# Access Compliance Report Public Rights-of-Way (Curb Ramps)

Main Street: PLUM\_ST Cross Street: CELESTINE\_CIR Location: NW

ADA ID: RPAT211029122828 Ramp Type: Type 4 - Parallel Initial Pass/Fail: Pass Overall Compliance: No Severity Score: 16

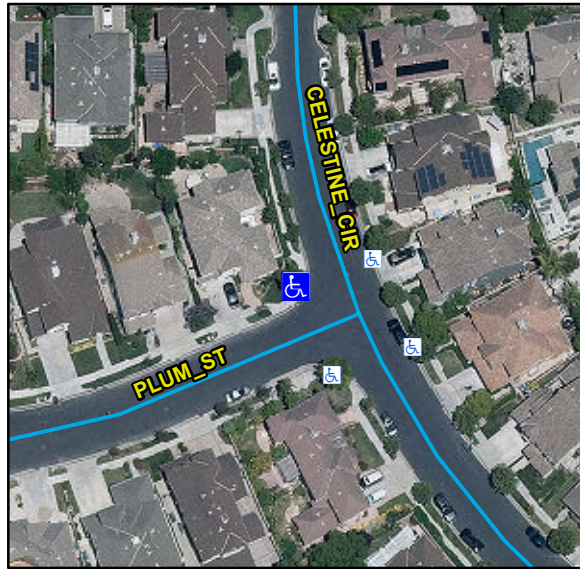
**R204.3, R304.2.2-Perp, R304.3.2-Para, R305, R302.7, R304.5.4, STD 1115**

| Compliance | Description                   | Data       | Compliance | Description                   | Data |
|------------|-------------------------------|------------|------------|-------------------------------|------|
| N/A        | Landing Present               | Yes        | No         | DWS Provided                  | No   |
| No         | Landing Run Slope (%)         | 4.4        | N/A        | DWS Full Width                | N/A  |
| No         | Gutter Ponding                | Yes        | Yes        | Curb Slope                    | 0.2  |
| No         | Gutter Run Slope (%)          | 8          |            | Road Cross Slope (%)          | 1.2  |

**Remove & Replace Curb Ramp With Two New Directional Ramps or Equivalent. Remove & Replace Gutter.**
